# UNITED STATES PATENT AND TRADEMARK OFFICE

APPLICATION NO.	FILING DATE	FIRST NAMED INVENTOR	ATTORNEY DOCKET NO.	CONFIRMATION NO.
10/733,260	12/12/2003	Toru Takayama	0756-7226	8689
31780	7590	10/05/2007		
ERIC ROBINSON PMB 955 21010 SOUTHBANK ST. POTOMAC FALLS, VA 20165			EXAMINER LOPEZ ESQUERRA, ANDRES	
			ART UNIT 2818	PAPER NUMBER
			MAIL DATE 10/05/2007	DELIVERY MODE PAPER

## Office Action Summary

## **DETAILED ACTION**

FIG. 8

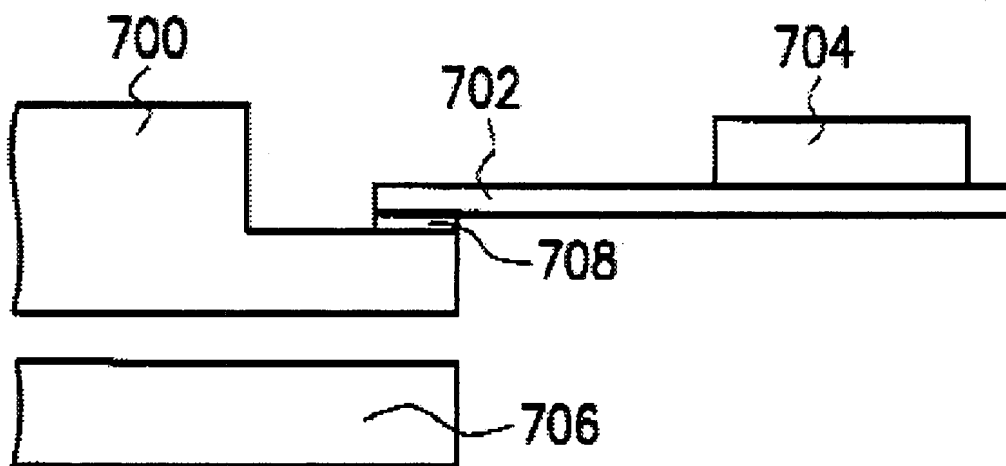
8. As for claim 1, Chen discloses (Col. 5, line 34 – Col. 6, line 3) and shows in Fig. 8 a flat LCD driver IC module comprising:

- a. a substrate (702) having a contact hole (Chen discloses Col. 5, lines 54 – 56, that the substrate 702 include interconnecting wiring and therefore contact holes in it);
- b. a display device (700, 706) equipped on one side of the substrate; and
- c. a thin film integrated circuit (704) equipped on the other side of the substrate, wherein the display device is electrically connected to the thin film integrated circuit through the contact hole (Chen discloses Col. 5, lines 54 – 63,

that the substrate 702 include interconnecting wiring and therefore contact holes in it and that the same are connected to the LCD 700).

13. As for claims 4, 7 and 10, Chen discloses (Col. 5, line 34 – Col. 6, line 3) and shows in Fig. 8 a flat LCD driver IC module comprising:

- d. a substrate (702) having a contact hole (Chen discloses Col. 5, lines 54 – 56, that the substrate 702 include interconnecting wiring and therefore contact holes in it);
- e. a display device (700, 706) equipped on one side of the substrate; and
- f. a plurality of thin film integrated circuits (704) equipped on the other side of the substrate, wherein the display device is electrically connected to the thin

film integrated circuits through the contact hole (Chen discloses Col. 5, lines 54 – 63, that the substrate 702 include interconnecting wiring and therefore contact holes in it and that the same are connected to the LCD 700), and wherein the display device is an active matrix type (Col. 5, lines 27 – 29).

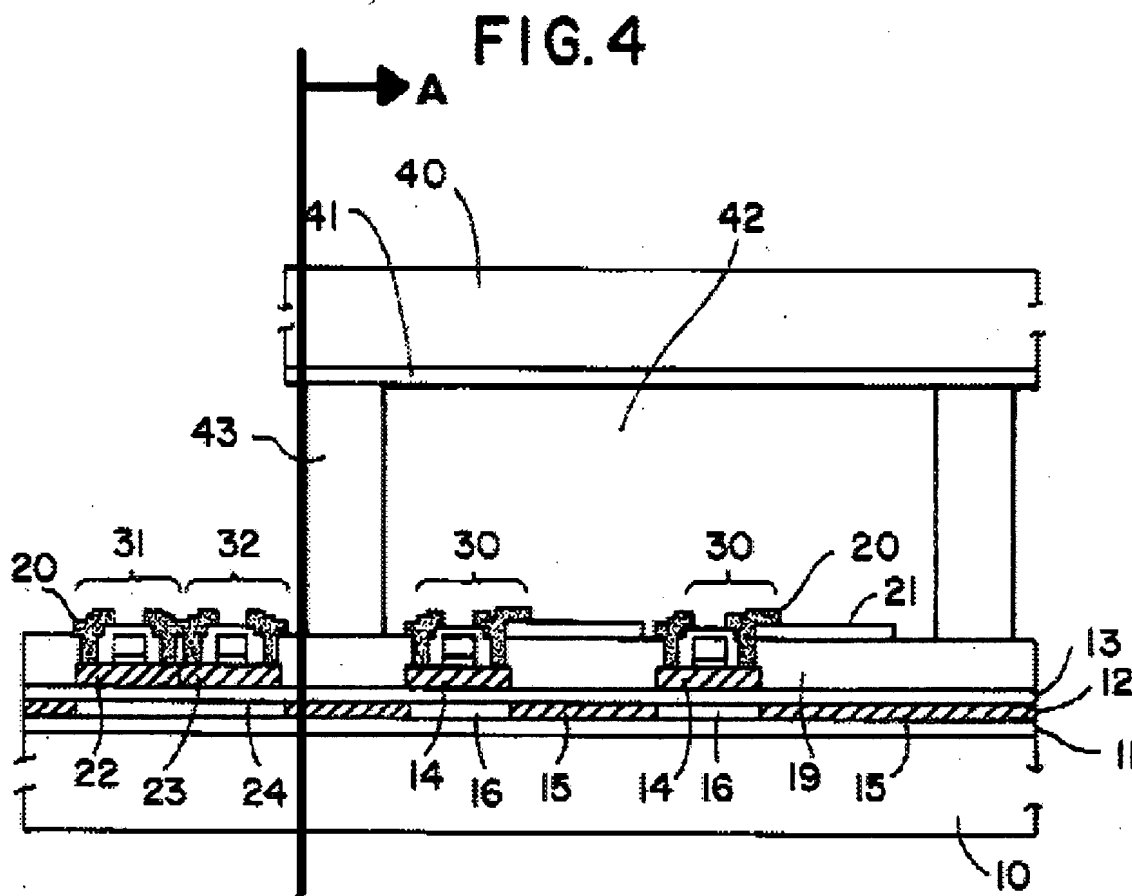
10. Kusumoto discloses (Col. 7, lines 33 – 58, Col. 4, line 10 – 20) and shows in Fig. 4 a LCD display (A) with a peripheral driving circuit (31, 32) where both use a polycrystalline semiconductor layer (14, 22, 24) on the construction.

15. Kusumoto discloses (Col. 7, lines 33 – 58, Col. 4, line 10 – 20) and shows in Fig. 4 a LCD display (A) with a peripheral driving circuit (31, 32) where both use a polycrystalline semiconductor layer (14, 22, 24) on the construction.
